**Identification cards — Contactless
integrated circuit cards — Proximity
cards —**

**Part 3:
Initialization and anticollision**

**AMENDMENT 1: Electromagnetic
disturbance handling and single-size unique
identifier**

AMENDMENT 1: Electromagnetic disturbance handling and single-size unique identifier

Figure 17 — Timing before the PICC SOF

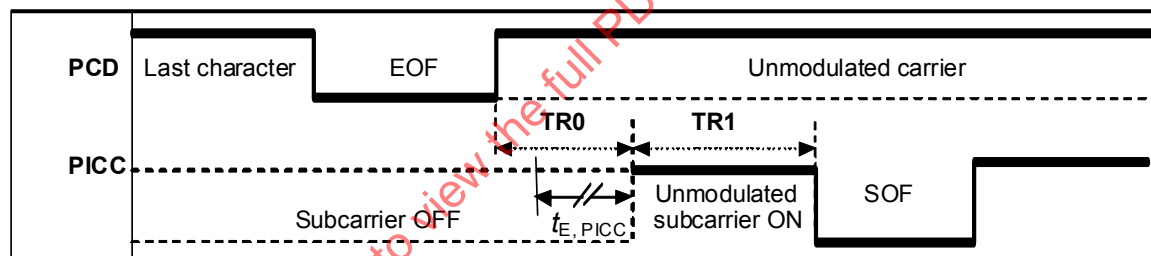
Page 27, 7.1.6

Replace Figure 17 with the following:

NOTE $t_{E, PICC}$ is specified in Clause 8.

Figure 33 — Low EMD time

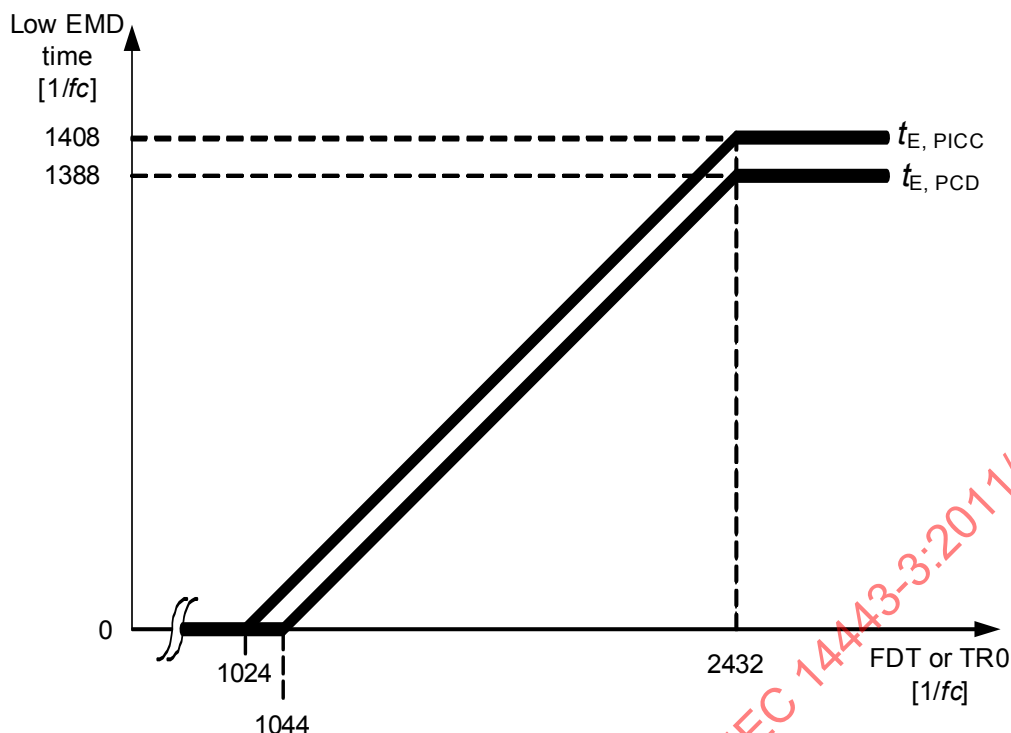
Page 47

Insert the following new clause after Figure 32:

The low EMD time for PCD and PICC are illustrated in Figure 33.

The low EMD time $t_{E,PICC}$ is the time period before the start of PICC data transmission, when the PICC shall not produce an EMD level higher than the EMD limit as defined in ISO/IEC 14443-2/Amd.1.

This low EMD time $t_{E,PICC}$ has a value of $F - 1024/f_c$ with a maximum value of $1408/f_c$ where F equals FDT for Type A and TR0 for Type B. The value is $0/f_c$ for $TR0 \leq 1024/f_c$.

The low EMD time $t_{E,PCD}$ is the time period to allow the PCD to recover from electromagnetic disturbances.

The PCD shall be ready to process a PICC frame no later than $t_{E,PCD}$ after the last time the EMD level was above the EMD limit as defined in ISO/IEC 14443-2/Amd.1.

This low EMD time $t_{E,PCD}$ has a value of $F - 1044/f_c$ with a maximum value of $1388/f_c$ where F equals FDT for Type A and TR0 for Type B. The value is $0/f_c$ for $TR0 \leq 1044/f_c$.
